## MEMORANDUM

To: City of Scottsdale, Planning & Development Services  
From: Lauren Proper Potter, Huellmantel & Affiliates  
Re: 9-ZN-2021 – Palo on 75<sup>th</sup> 1<sup>st</sup> Review  
Date: September 29, 2021

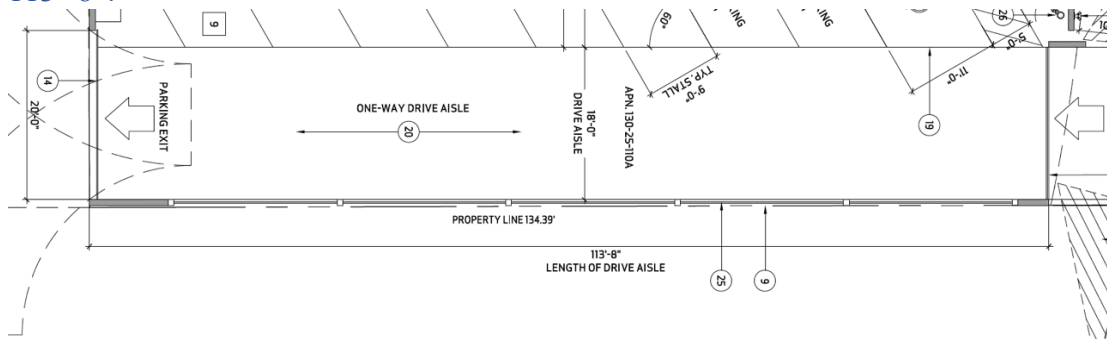
- *The preliminary water and sewer Basis of Design (BOD) reports have been conditionally accepted by the Water Resources Division. The following will be stipulations to any future approval:*
  - *A new 6-inch sewer service line will be required.*
  - *The on-site sewer shall be private and located within the proposed drive aisle.*
  - *Final water and sewer BOD's will be required with the Development Review Board submittal. With the final sewer BOD, please provide a utility plan showing private sewer, unit connections and connection to 6-inch primary private service line and public sewer. Refer to Section 7-1.201 of the DSPM.*

Thank you. Final reports will be submitted with a permit submittal following successful entitlement of the site.

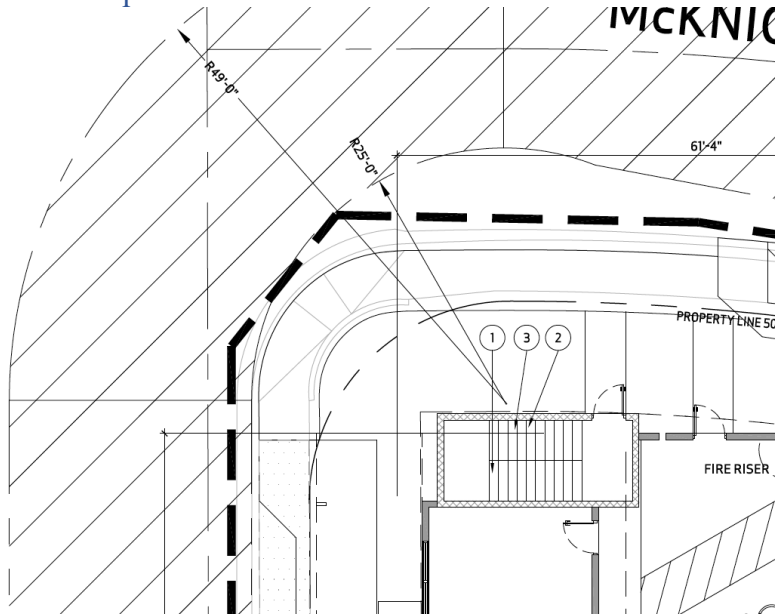
- Provide and demonstrate turning radii on site plan (25' inside, 49' outside and 55' bucket swing per DS&PM Sec 2-1.303(5))

We have provided a Fire Access Plan that demonstrates the turning radii.
